MELROSE PARK SOUTH-WEST BLOCK B2 & B3

Design Report – State Significant Development Application (SSD-71558711)
Response to DPHI Issues Letter

Prepared for
Wharf and Hughes Developments Pty Ltd.

Issued
28 November 2025

Solar Access - B3

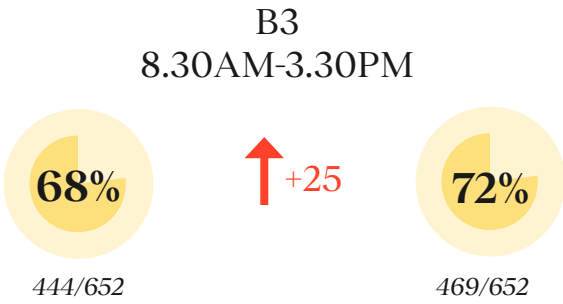
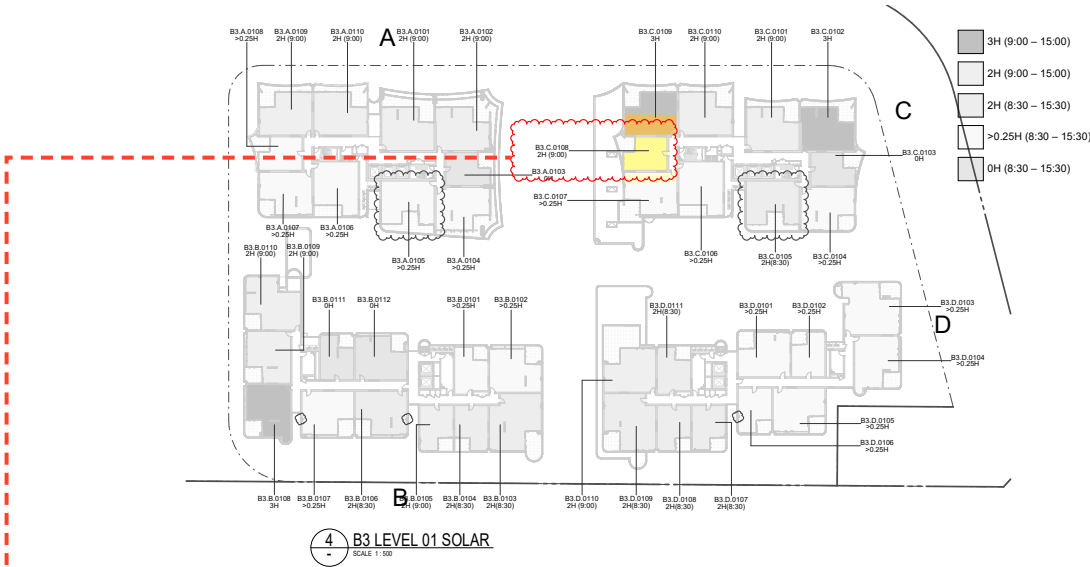
- Solar access performance across Blocks B1 and B3 and the overall development does not meet the Apartment Design Guide (ADG) solar access recommendations. The Department notes 70% solar access in midwinter is still not achieved for all blocks, even with consideration of an additional hour in midwinter (8.30 am to 3.30 pm). You are therefore requested to:
 - further investigate the design to achieve an improved solar access outcome
 - confirm the design measures undertaken to maximise solar access within each block to living areas/private open space and to communal open space.

- Provide further information demonstrating Block B2 achieves consistency with the ADG solar access provisions in midwinter.

- The solar compliance drawings for Blocks 2 and 3 have been reviewed for accuracy, including further 3D camera analyses within each apartments. One apartment stack in Block 3 previously identified as >0.25 hours should have been classified as 2H 9-3; this correction has now been reflected in the updated drawing set. Colour coding has also been revised to align with the legend for clarity.

- The solar compliance drawings for Blocks 2 and 3 have been reviewed for accuracy, including further 3D camera analyses within each apartments. One apartment stack in Block 3 previously identified as >0.25 hours should have been classified as 2H 9-3; this correction has now been reflected in the updated drawing set. Study is shown in this report.

- B3.C.xx08 stack. Previously identified as >0.25 but should be 2H 9-3, (example to the right)
 - B3.A.0604
 - B3.A.0308
 - B3.A.0307
 - B3.C.0407
 - Room colours on drawings have also been adjusted to match the legend on the drawings to further clarify the calculation.

Natural Ventilation - B3

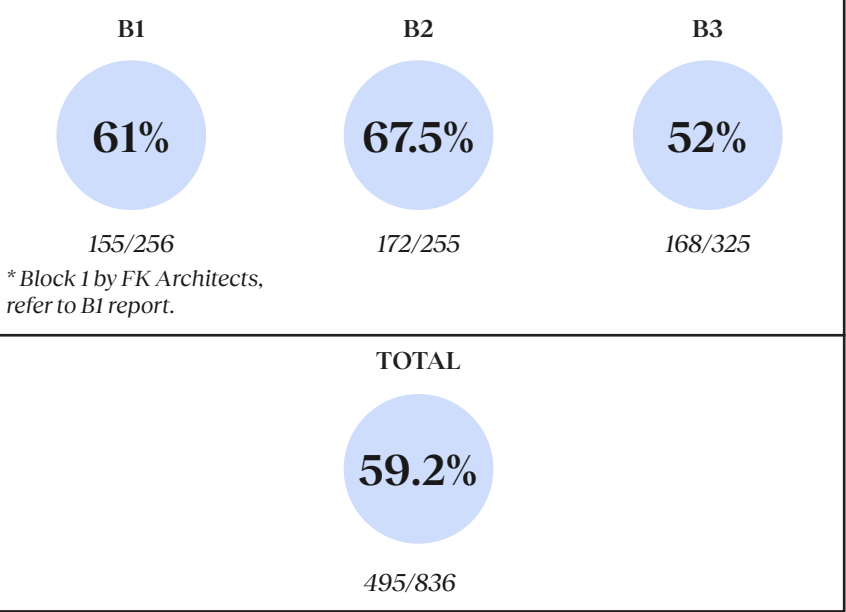
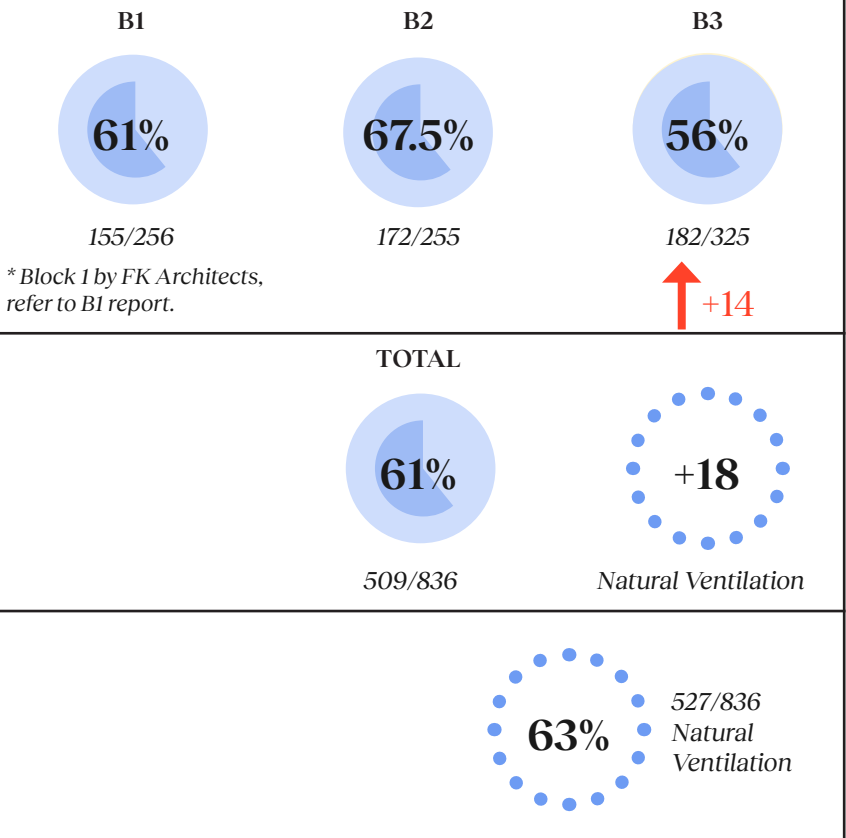
- Review the natural ventilation calculations for Blocks B1 and B3 noting a number of apartments do not appear to be naturally ventilated despite being counted as naturally ventilated in the ADG calculations for each building. Provide justification for any blocks not achieving the ADG natural ventilation recommendations if required following review

- Provide further information where natural ventilation is proposed via facade articulation.

- In the consultant's natural cross ventilation report for Building B3, 168 out of 325 apartments were identified as achieving natural cross ventilation through dual facades and significant pressure differentials between openings. These apartments are documented as naturally cross-ventilated in the submitted ADG compliance drawings.

- The consultant's report also identified an additional 17 apartments with potential to achieve cross ventilation subject to minor facade or layout modifications. Following a detailed review, SJB has determined that 14 of these apartments can be feasibly adjusted to achieve natural cross ventilation with minimal architectural impact. Apartments requiring layout adjustments are highlighted in this section, with detailed layouts provided in both the report and the drawing package. (Apartment stack B3.A.xx05 and B3.C.xx05)

- Beyond the cross-ventilated apartments, a further review was undertaken to enhance overall natural ventilation. Eighteen apartments will benefit from added windows to achieve dual-aspect ventilation. While these may not meet the full criteria for natural cross ventilation due to orientation, location, or wind pressure constraints, the additional openings significantly improve amenity and natural airflow.

2.3 Building Separation - B2

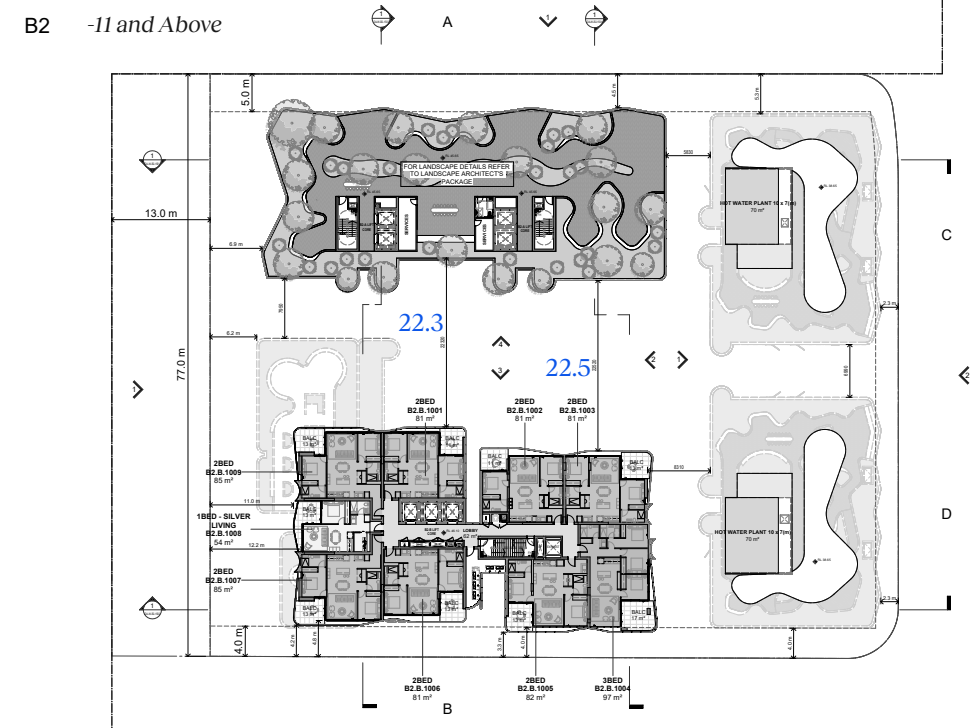
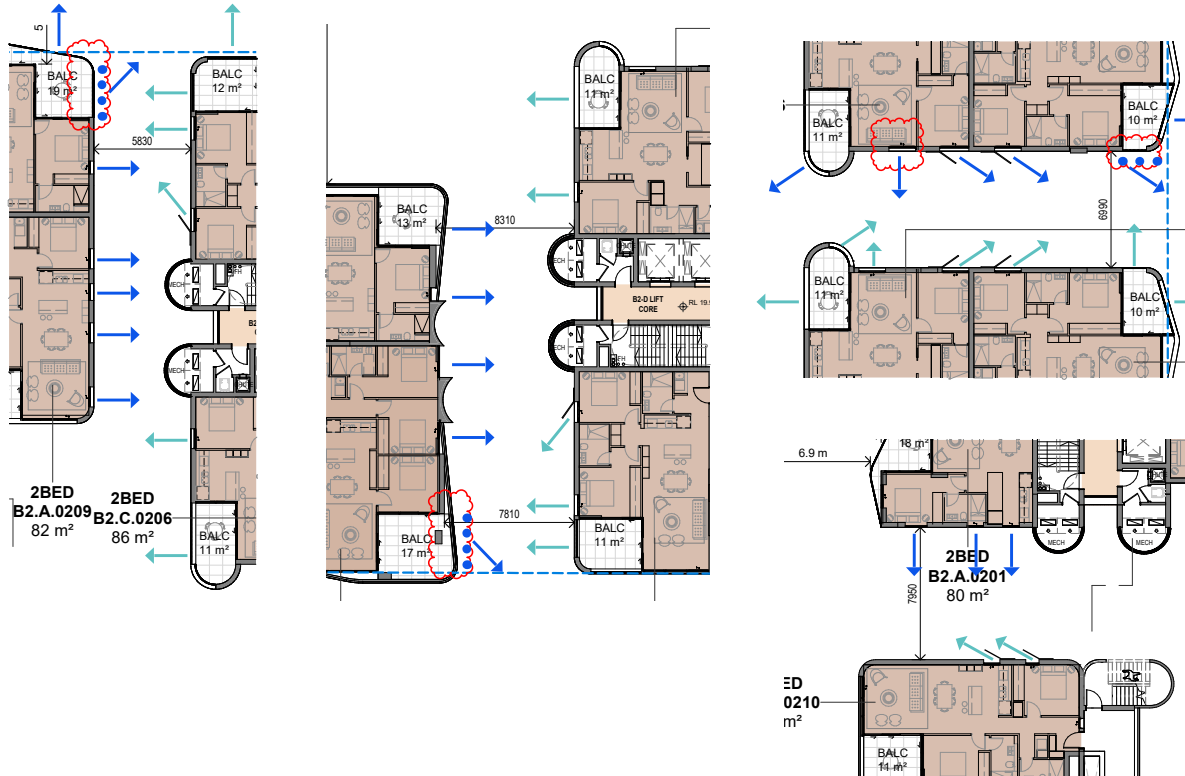
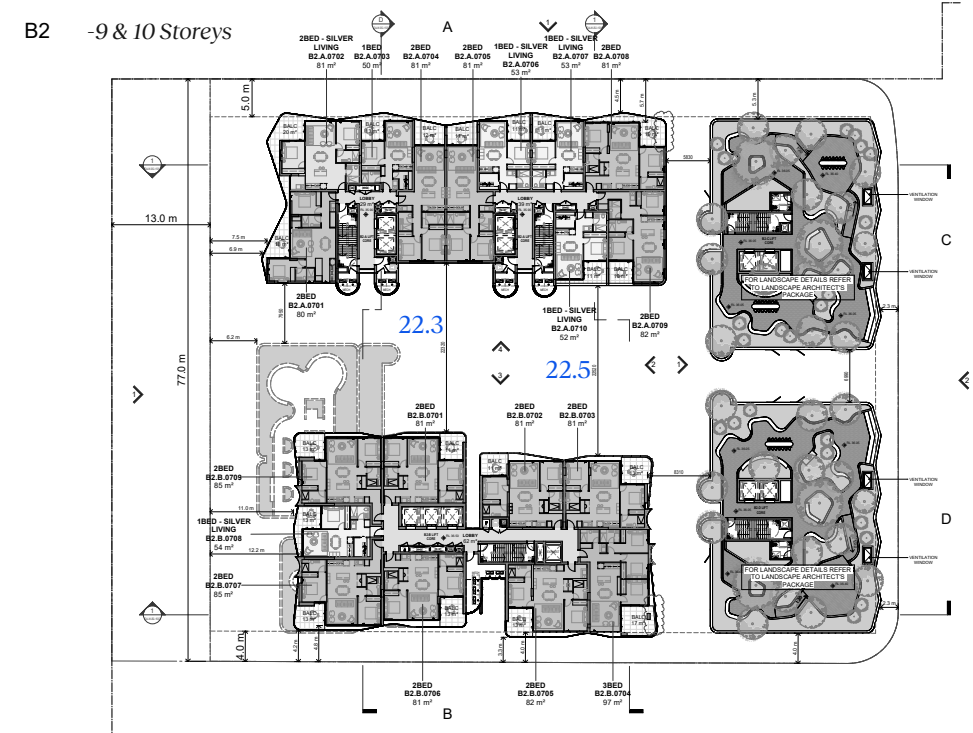
- Revise the Block B2 and B3 Design Report ADG Compliance Schedule to identify and include consideration of the ADG building separation design criteria re: internal building separation, including justification for proposed variations and proposed mitigation measures. Ensure the number of storeys are correctly counted from ground level re: calculation of the applicable recommended ADG building separation distances and associated justification for proposed variations.

- Where building separation varies from ADG guidelines due to design or site constraints, a range of mitigation strategies have been incorporated to manage potential privacy and amenity impacts. These include:
 - Staggering of openings to reduce direct overlooking
 - Incorporation of privacy fins to redirect views
 - Use of balcony louvres to balance privacy, outlook, and daylight access

B2

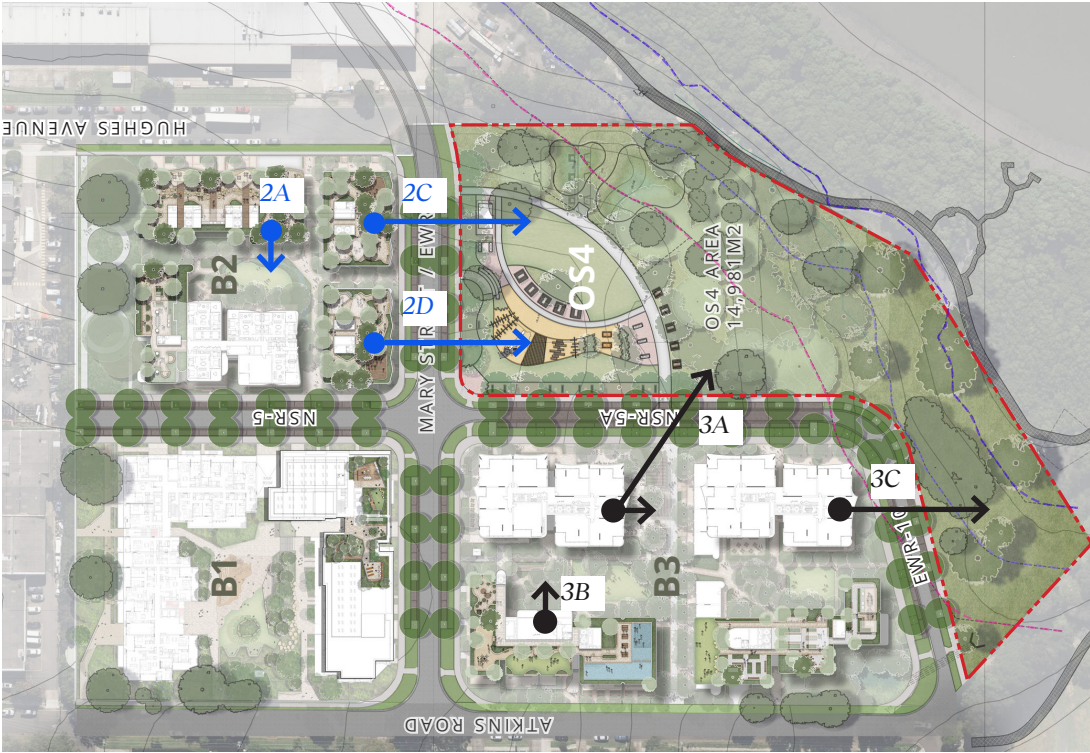
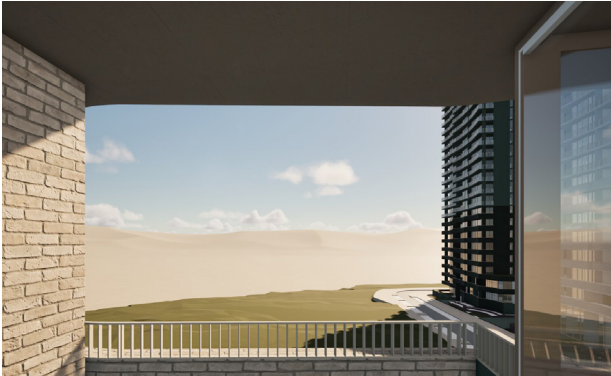
- Identify apartments that would receive nil solar access and are not cross ventilated and provide further information regarding how these apartments would still achieve an acceptable residential amenity outcome.

- SJB has identified apartments within Blocks 2 and 3 that receive less than two hours of solar access on 21 June and do not achieve natural cross-ventilation. A detailed internal review has been conducted to assess the overall living quality and amenity of these apartments.

- The findings indicate that the apartments will continue to provide a high level of amenity, supported by the following factors:
 - The broader precinct offers diverse community programs and facilities, including extensive green spaces, community areas, podium rooftop gardens, ground-level gathering spaces, site infrastructure, and retail opportunities.

- The apartments feature well-considered layouts with generous balconies.
 - Each dwelling has a beautiful outlook, with views toward the water, parklands, or internal courtyards.

- While they may not achieve two hours of direct sunlight in mid-winter, they will still receive natural light throughout the year.

Amenity

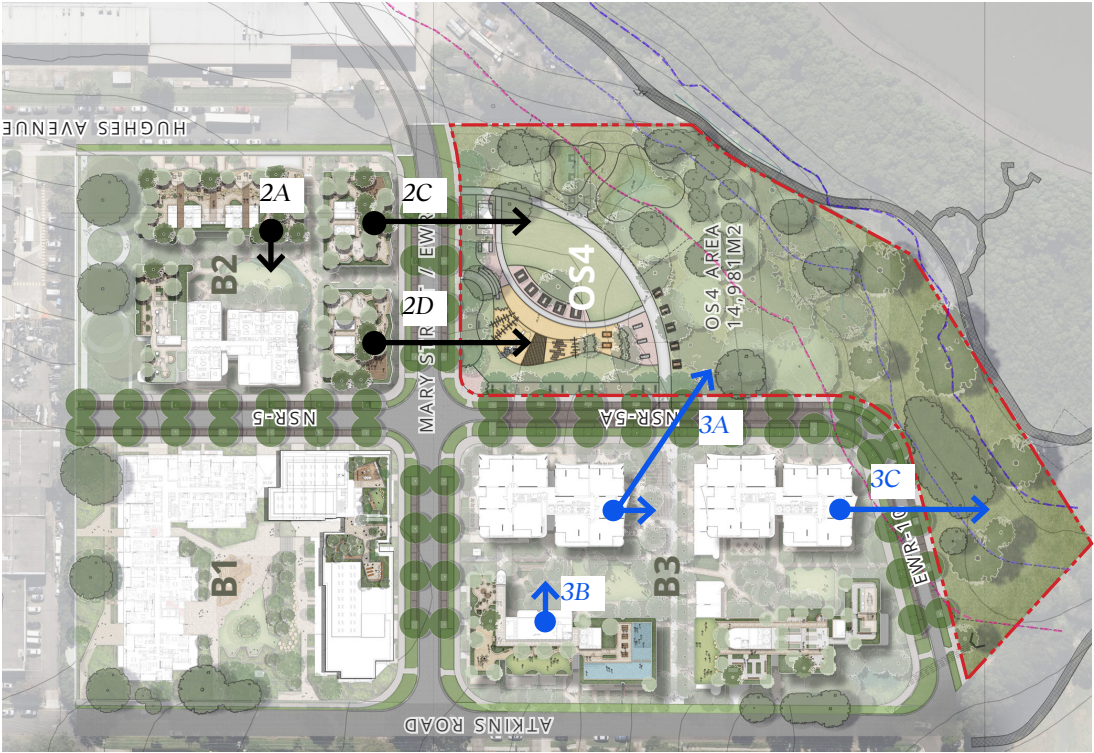
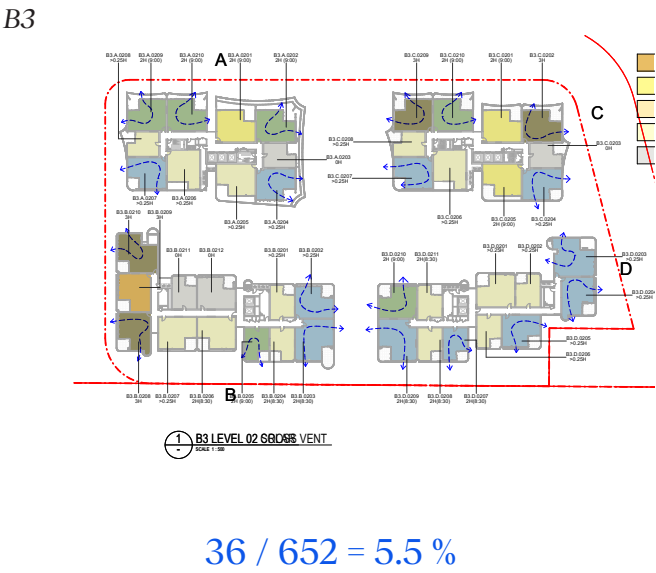
- Identify apartments that would receive nil solar access and are not cross ventilated and provide further information regarding how these apartments would still achieve an acceptable residential amenity outcome.

- SJB has identified apartments within Blocks 2 and 3 that receive less than two hours of solar access on 21 June and do not achieve natural cross-ventilation. A detailed internal review has been conducted to assess the overall living quality and amenity of these apartments.

- The findings indicate that the apartments will continue to provide a high level of amenity, supported by the following factors:
 - The broader precinct offers diverse community programs and facilities, including extensive green spaces, community areas, podium rooftop gardens, ground-level gathering spaces, site infrastructure, and retail opportunities.

- The apartments feature well-considered layouts with generous balconies.
 - Each dwelling has a beautiful outlook, with views toward the water, parklands, or internal courtyards.

- While they may not achieve two hours of direct sunlight in mid-winter, they will still receive natural light throughout the year.

1 STORAGE CAGE SCALE

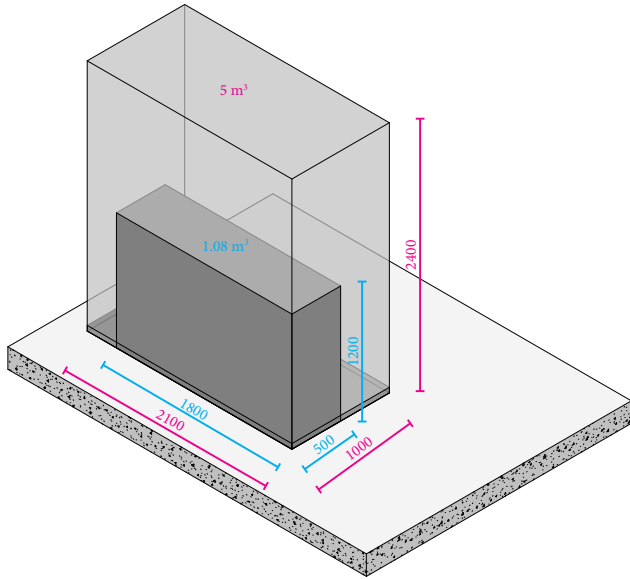
- Review the proposed basement storage volumes for apartments in Blocks B2 and B3 noting these should all exceed ADG minimums to provide additional storage space for bicycles given separate bicycle storage facilities for residents are not proposed.

- The storage cages have been reviewed, with external storage volumes calculated exclusive of bicycle parking areas. Storage spaces are provided in accordance with the ADG guideline.

Typical storage cages in basements are 5 m³.
Typical storage cages with bicycle storage include the bike volume of 1.08 m³ and additional storage volume of 3.92 m³ as per the diagram above.

2.6 Deep Soil / Landscaping

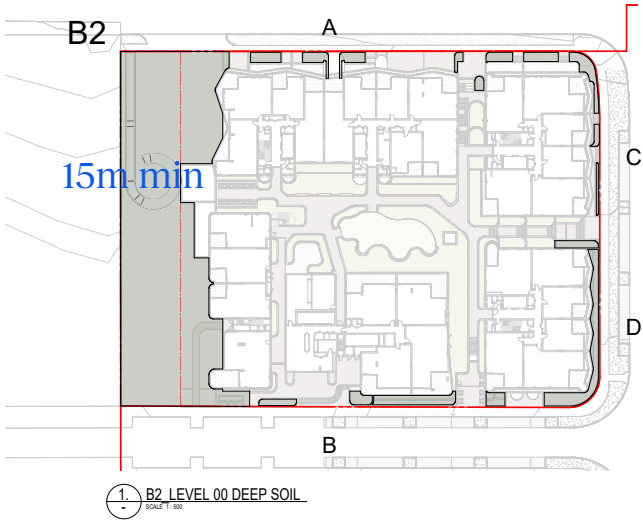
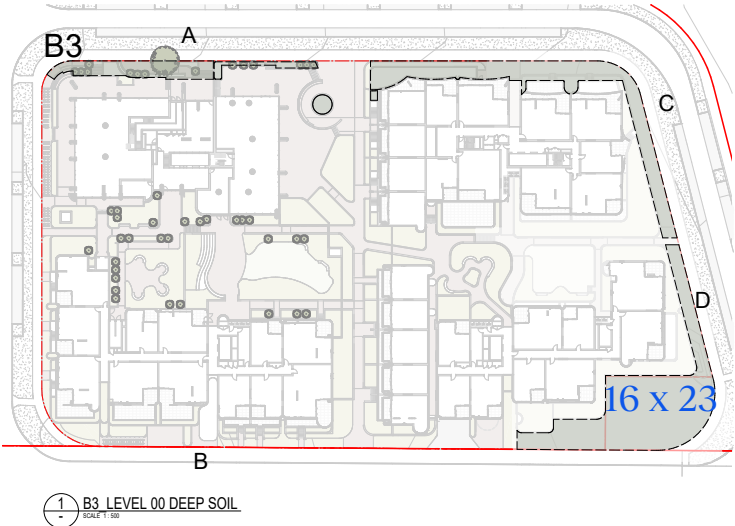
- Provide a table confirming deep soil zones (with a minimum dimension of 6 m and separately, between 3 m and 6 m) and landscaped areas within each block, the overall developable area of the site and the overall site

- The overall precinct strategy for deep soil is to provide a large and consolidated deep soil zone in OS4. To ensure meaningful deep soil zones can be achieve to support landscaping and slowing the water down for the precinct.
- In B2, the Western through site link has a minimum 15m width.
- In B3, the Eastern Southern corner has a 16m x 23m zone.

Communal Open Space - Rooftop Pool

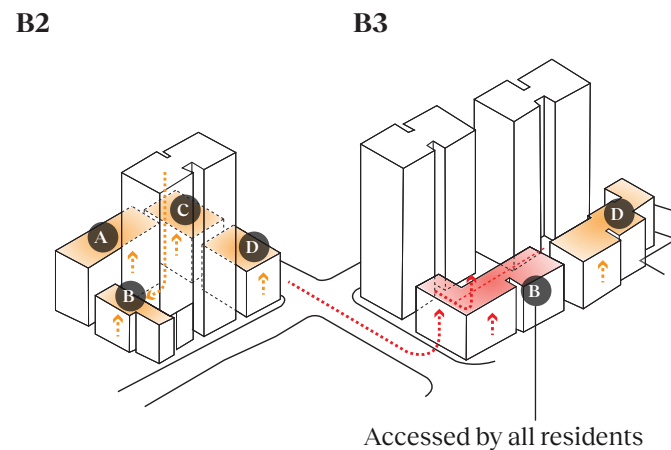
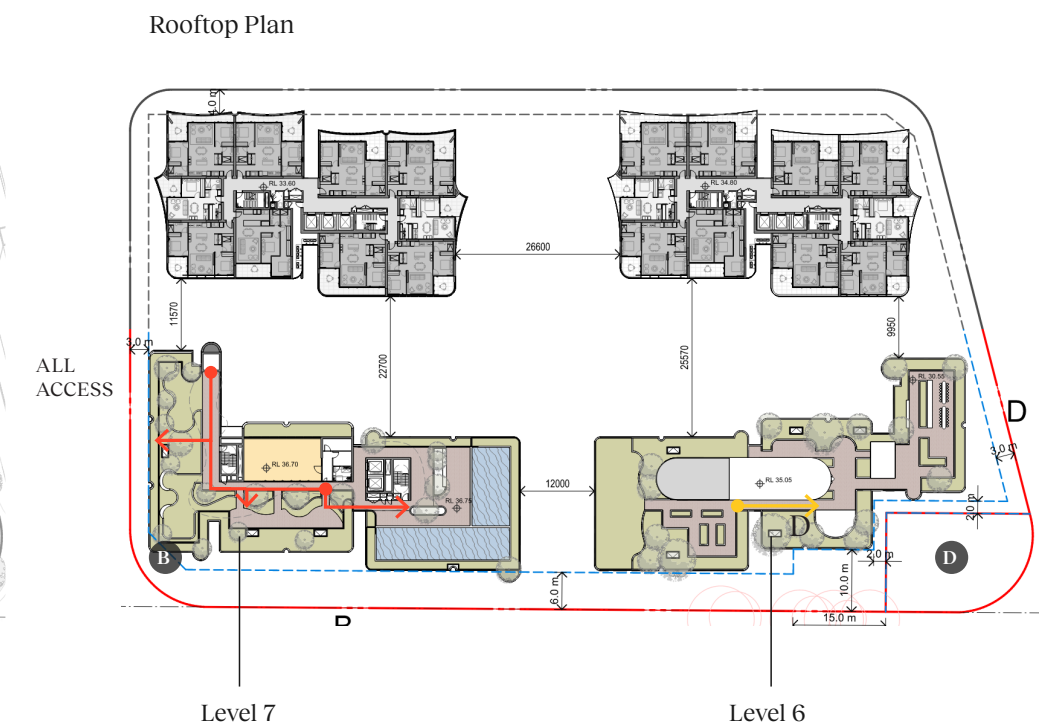
- Confirm rooftop communal open space areas would be available to residents of each building within the respective block.

- Each buildings in B2 has individual access to it's own communal roof open space.
- B3, block B and D have direct access to it's roof top gardens, block A and C shares the access to block B's roof top, which has a communal swimming pool. Block A and C's roof top will have challenging wind conditions and is better used for plants and PV panels.
- All blocks in B2 and B3 have access to it's internal courtyard communal spaces.
